RICE LIBRARY BUILDING COMMITTEE

Project Name: Rice Public Library Renovations & Addition
 Project #: 20 18 25
 Date: **Last revised on May 20, 2020**

**VE DRAWING PACKAGE
PROGRESS SET
Date of Issue : 5.27.2020**

RE: Rice Public Library Renovations & Additions, 8 Wentworth Street, Kittery, Maine
Revised Schematic Design Estimate with Accepted VE

1 LOWER LEVEL
1/8" = 1'-0"

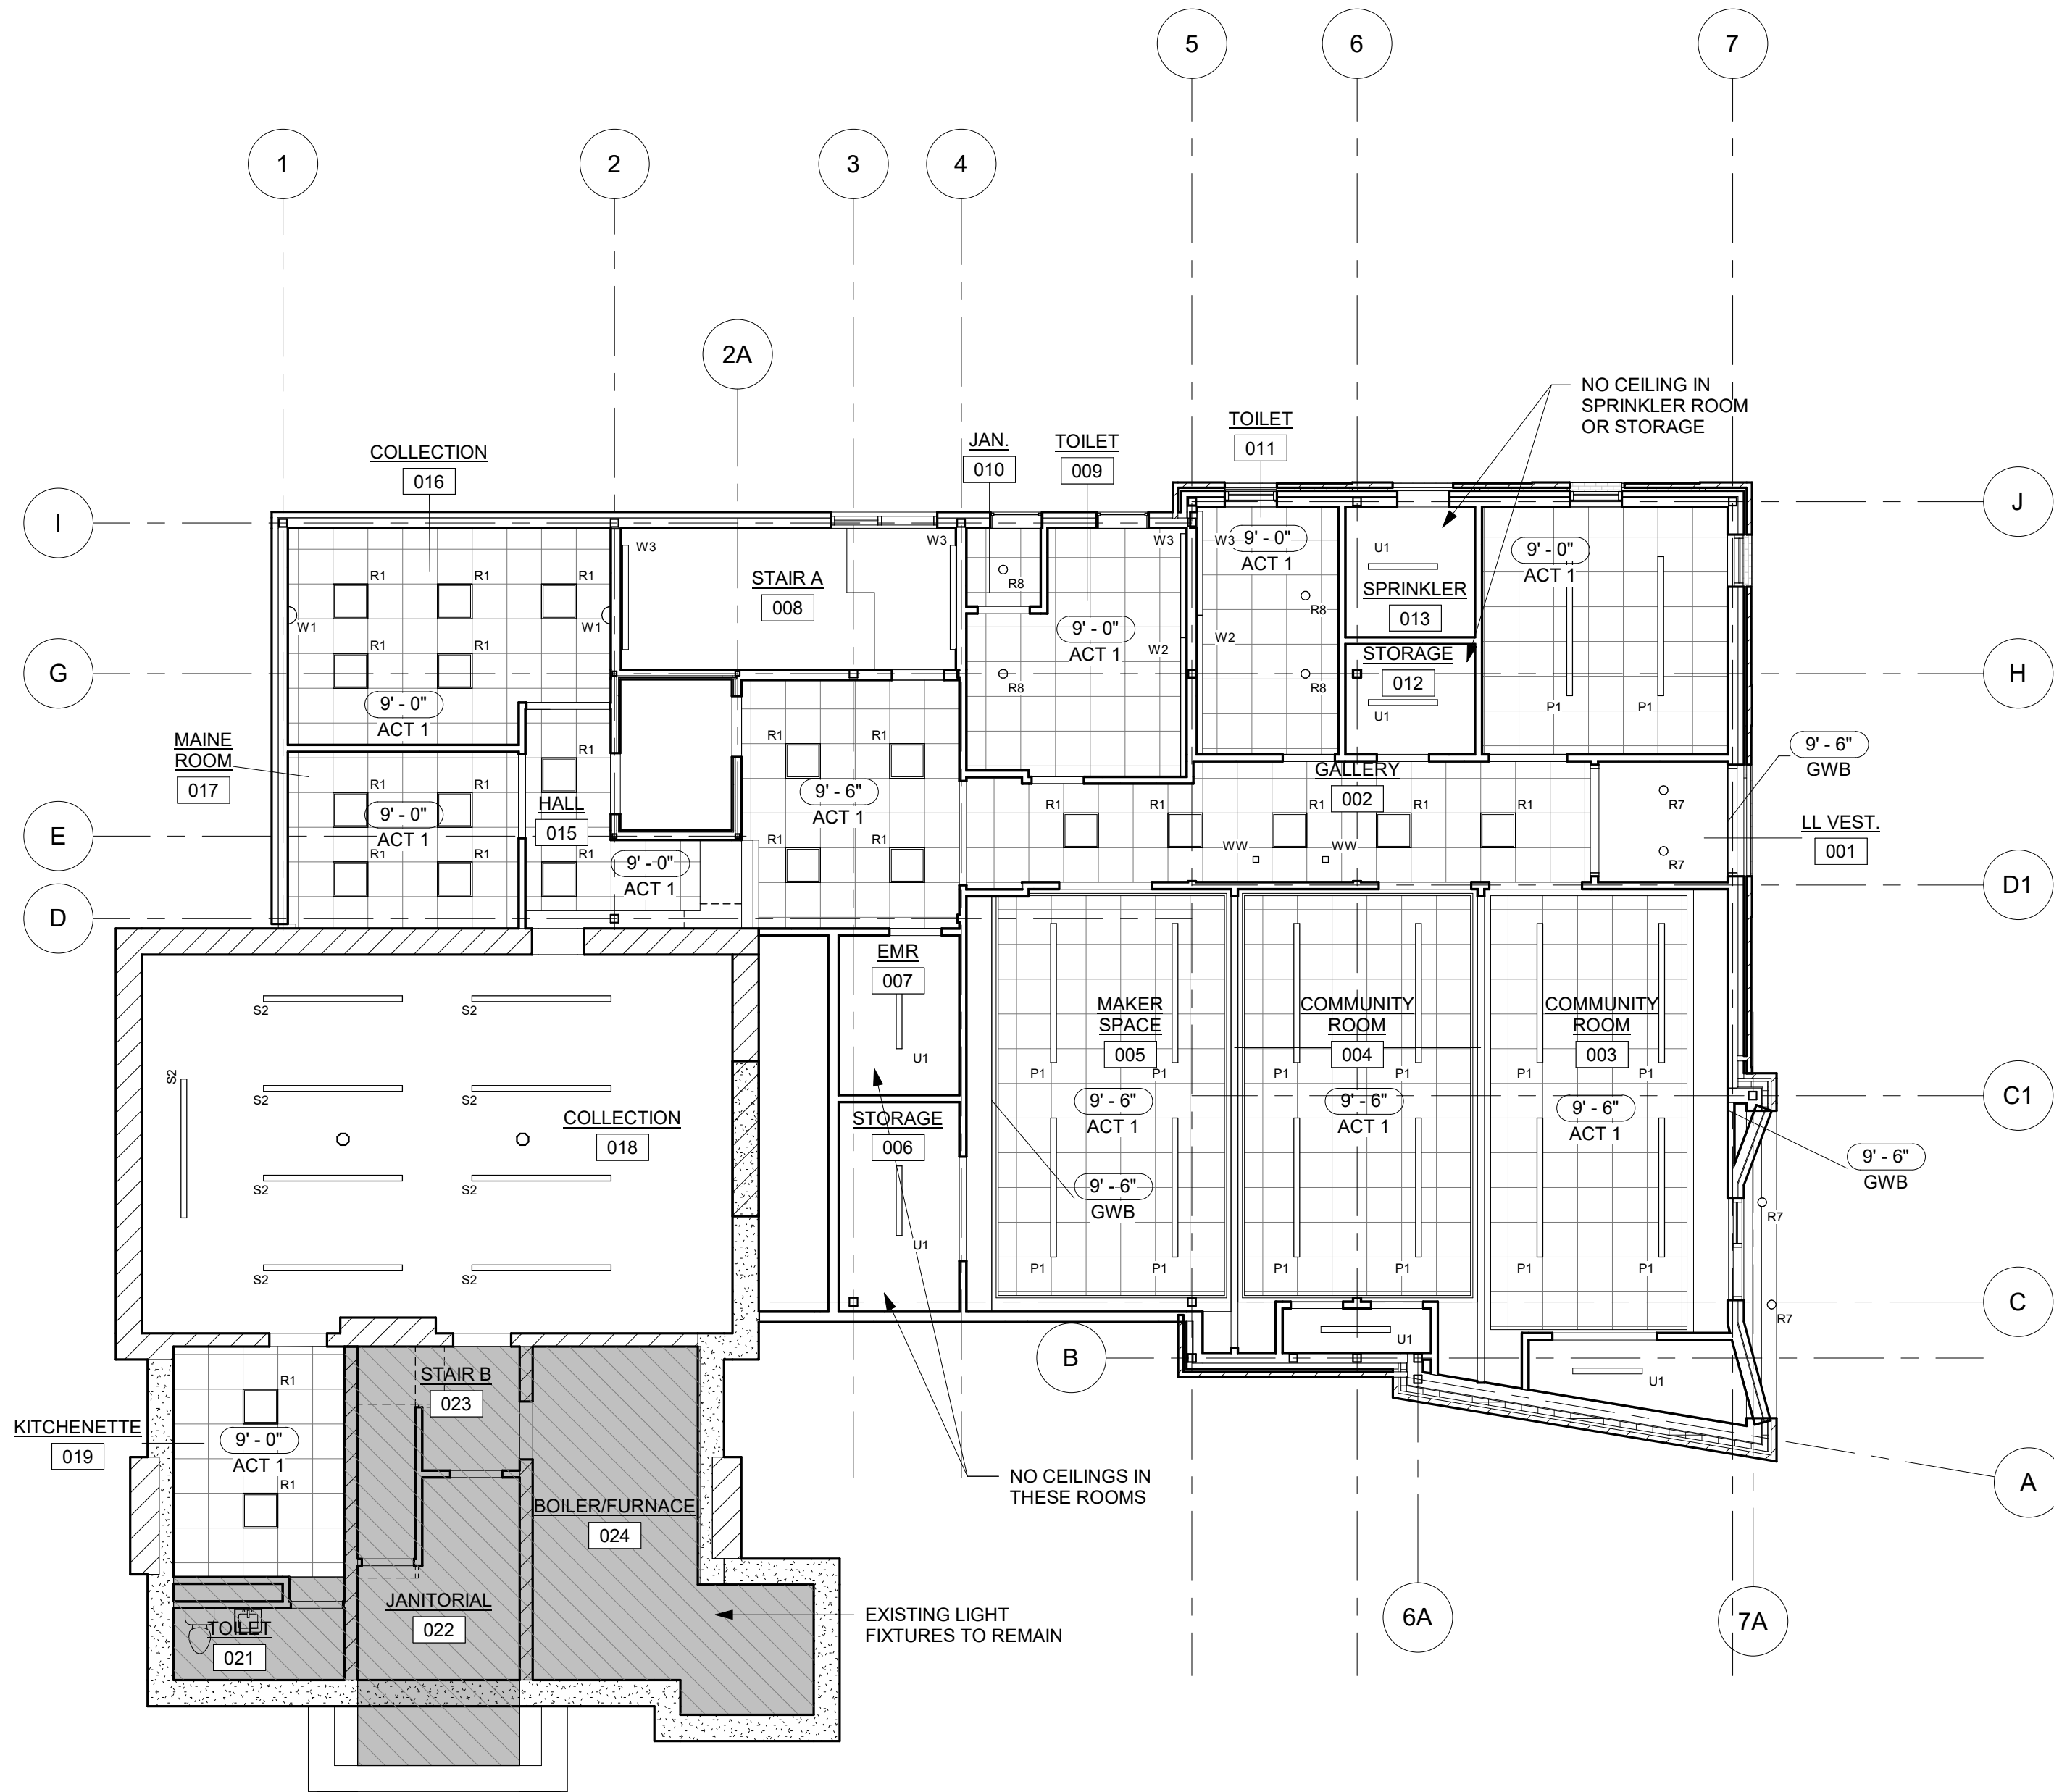
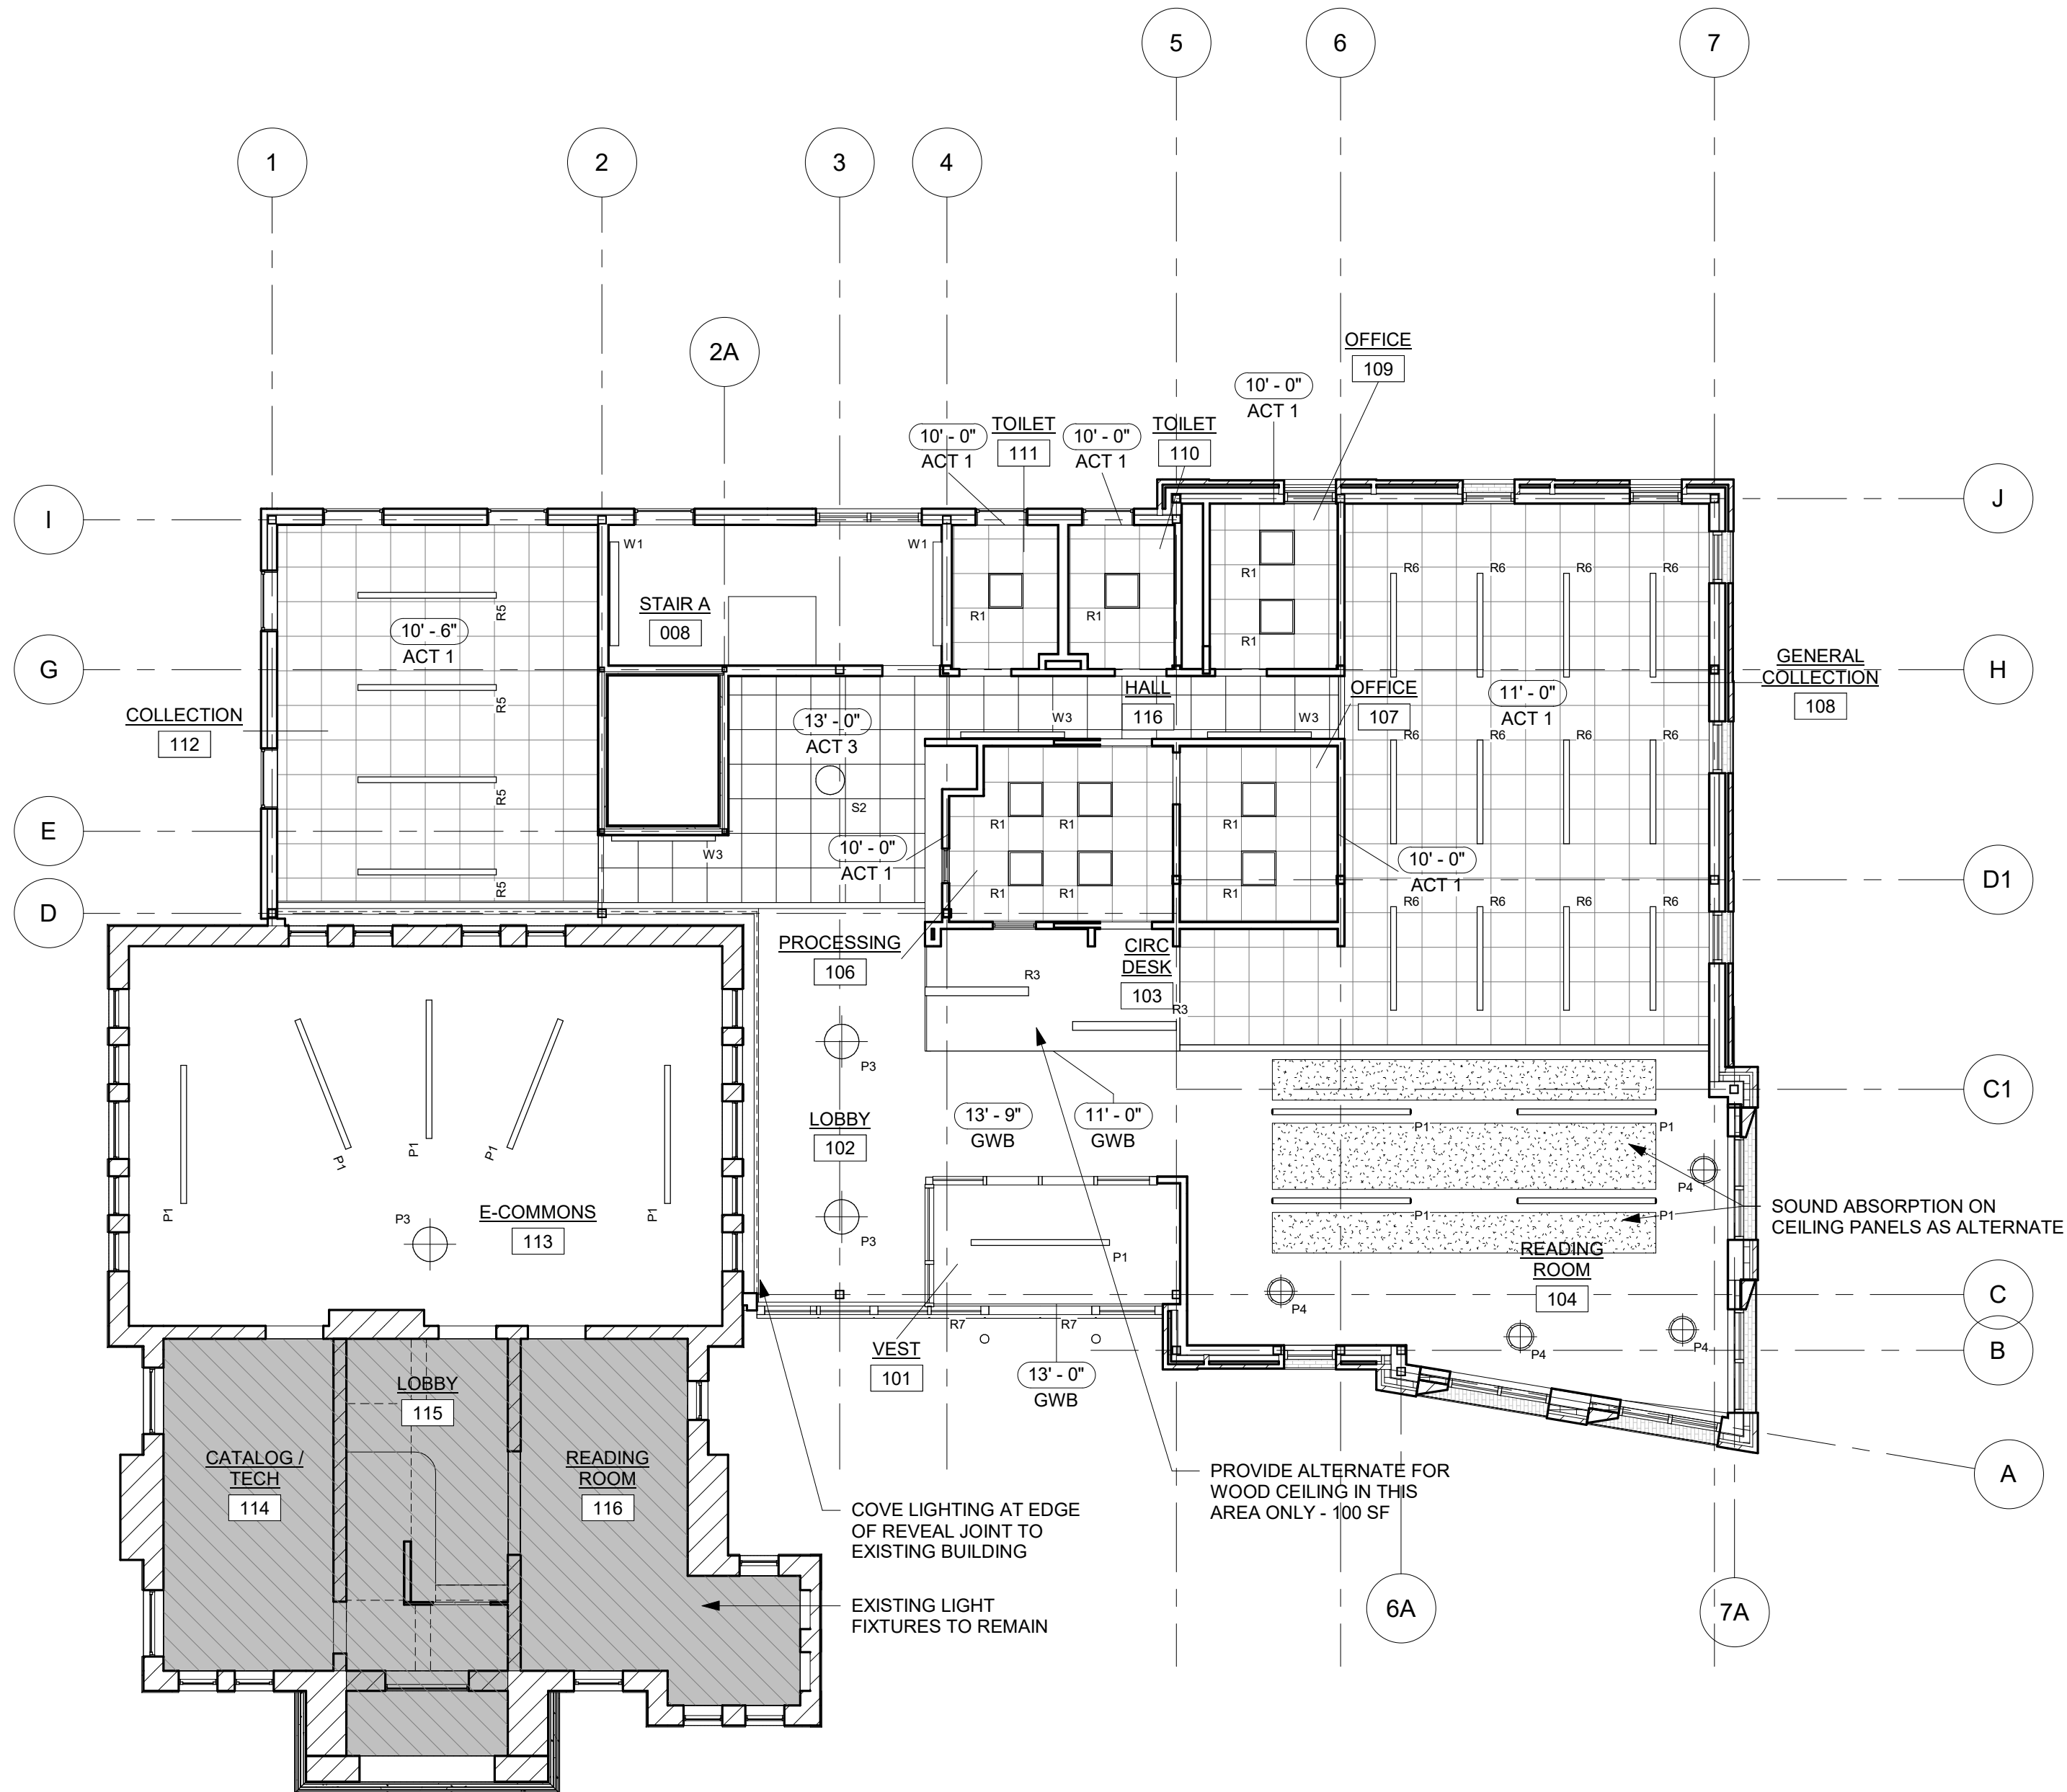
NOTE: REFLECTED CEILING PLANS ARE FOR CLARIFICATION OF
REDUCTION OF LIGHTING SCOPE AND DO NOT REFLECT THE
CHANGES TO CEILING TYPES.

SECOND FLOOR
REFLECTED CEILING
PLAN

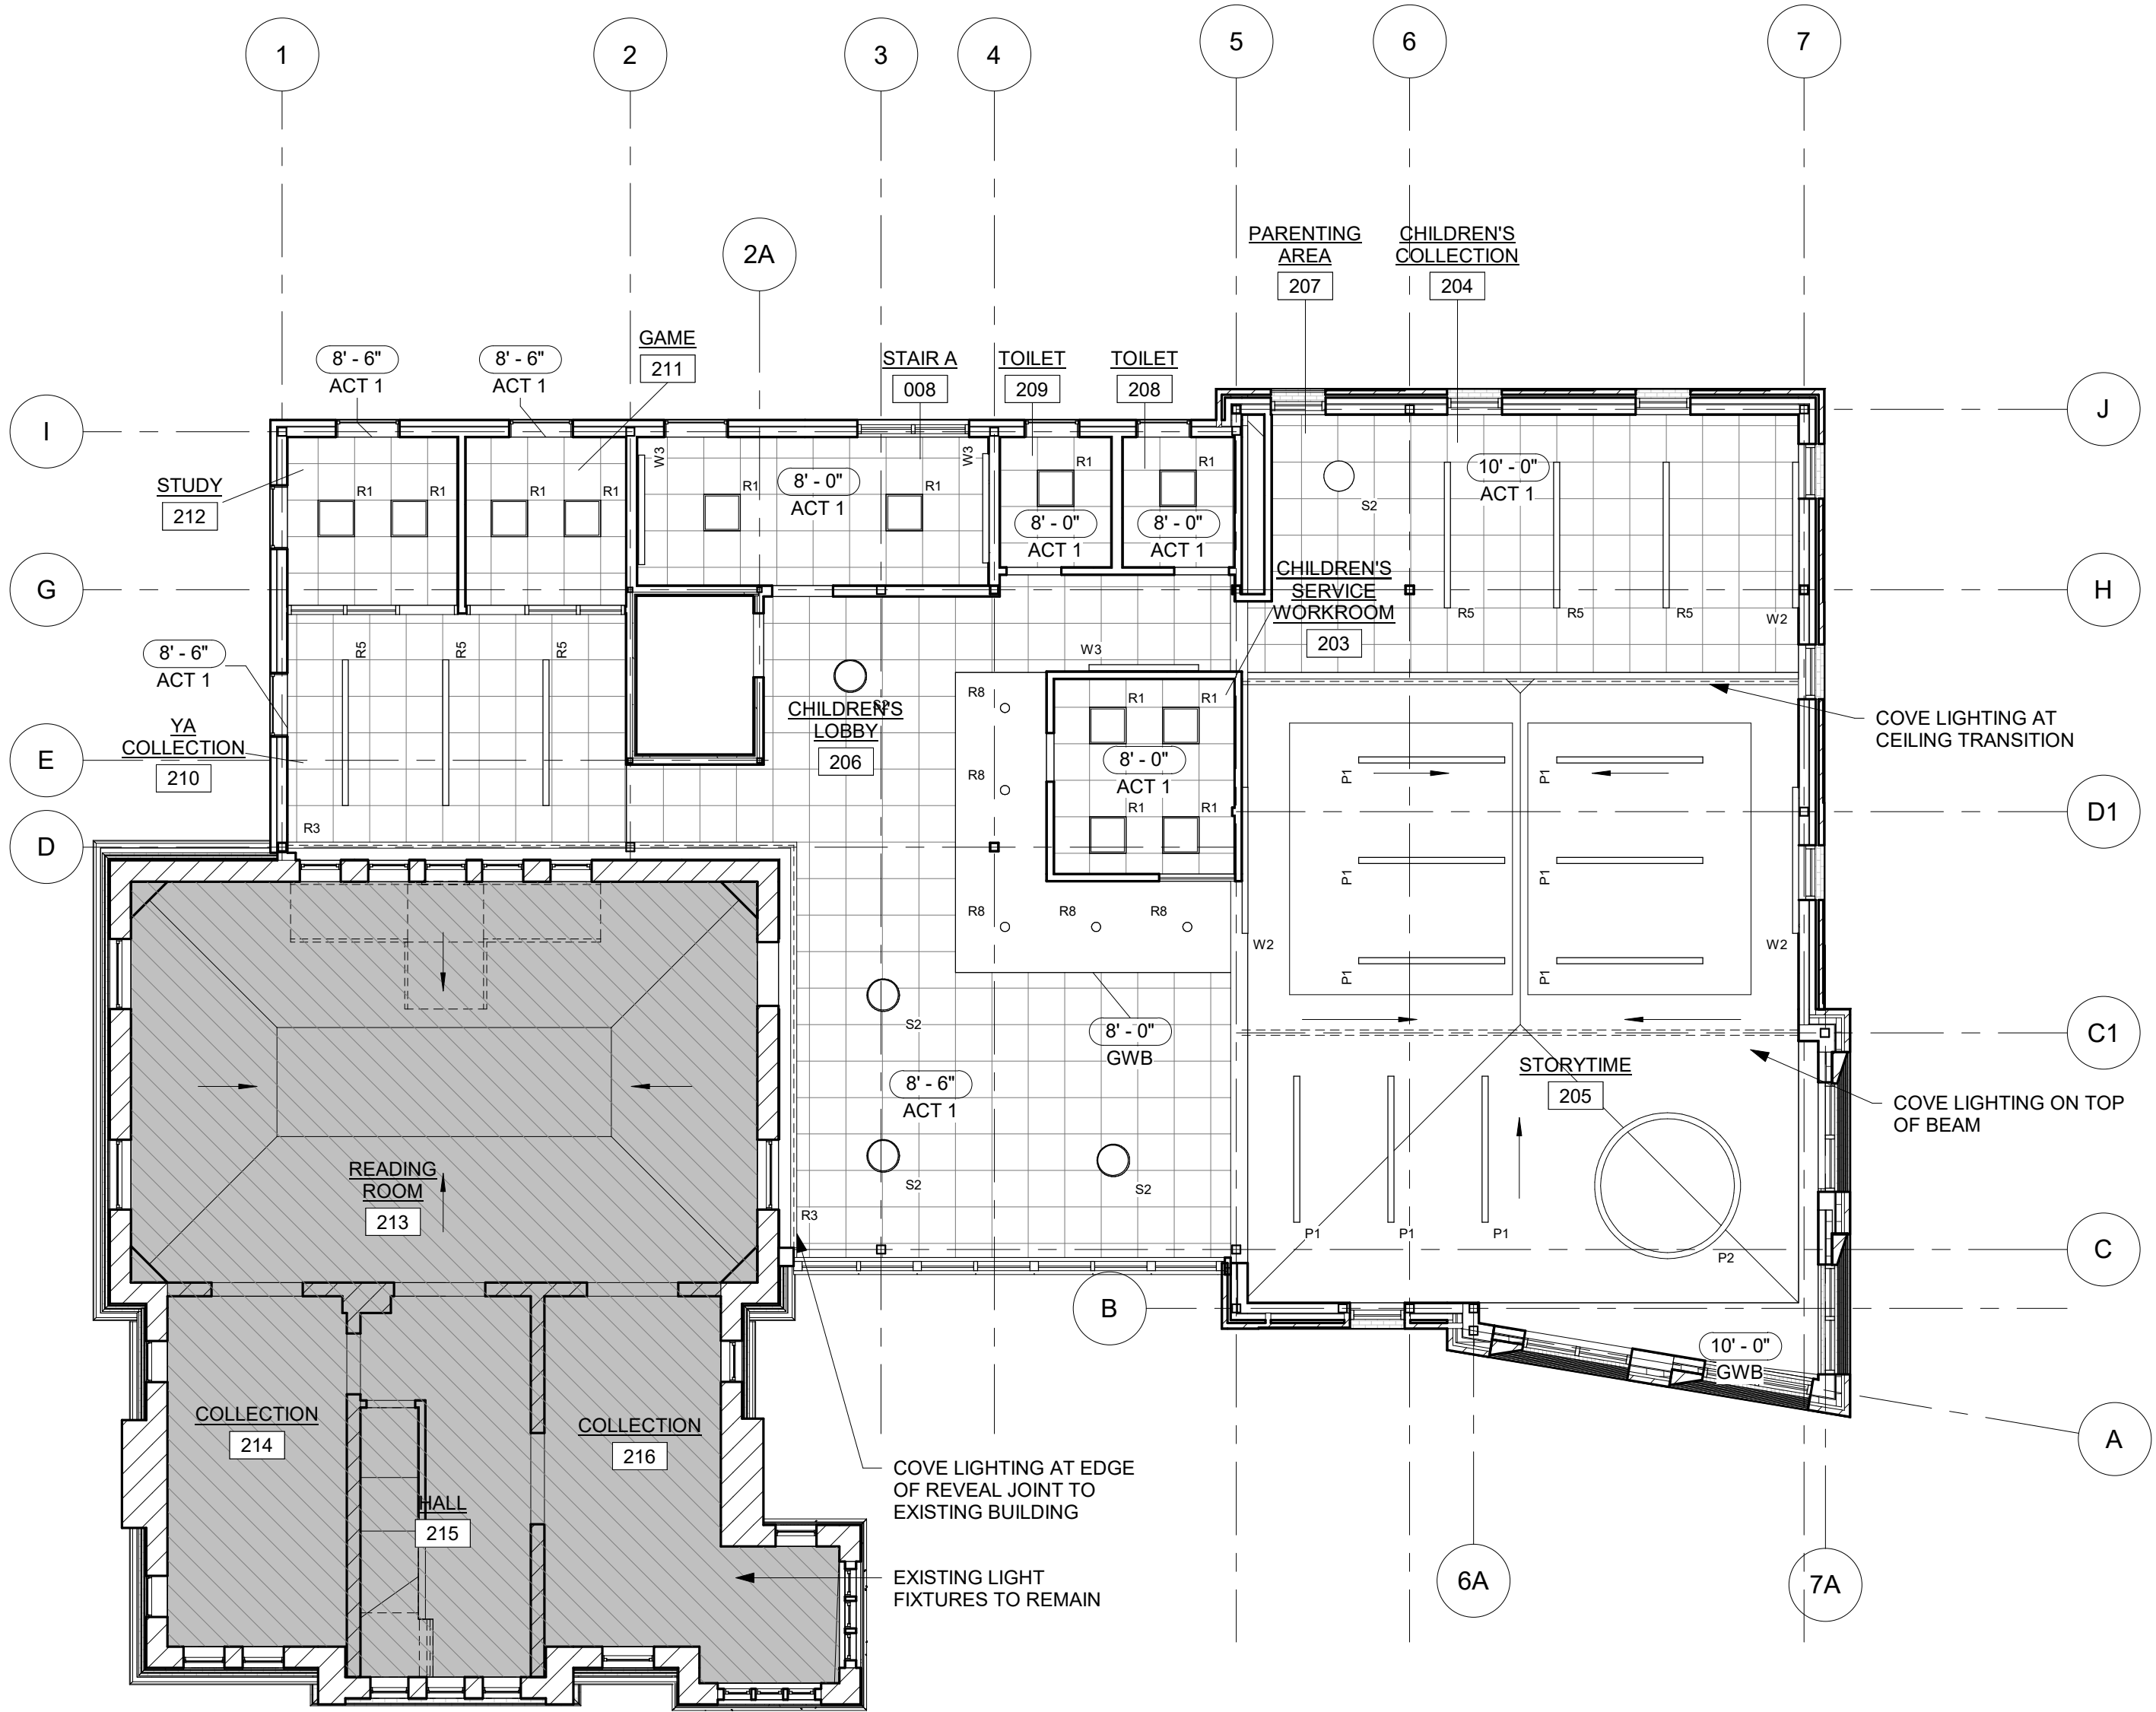
NOTE: REFLECTED CEILING PLANS ARE FOR CLARIFICATION OF
REDUCTION OF LIGHTING SCOPE AND DO NOT REFLECT THE
CHANGES TO CEILING TYPES.
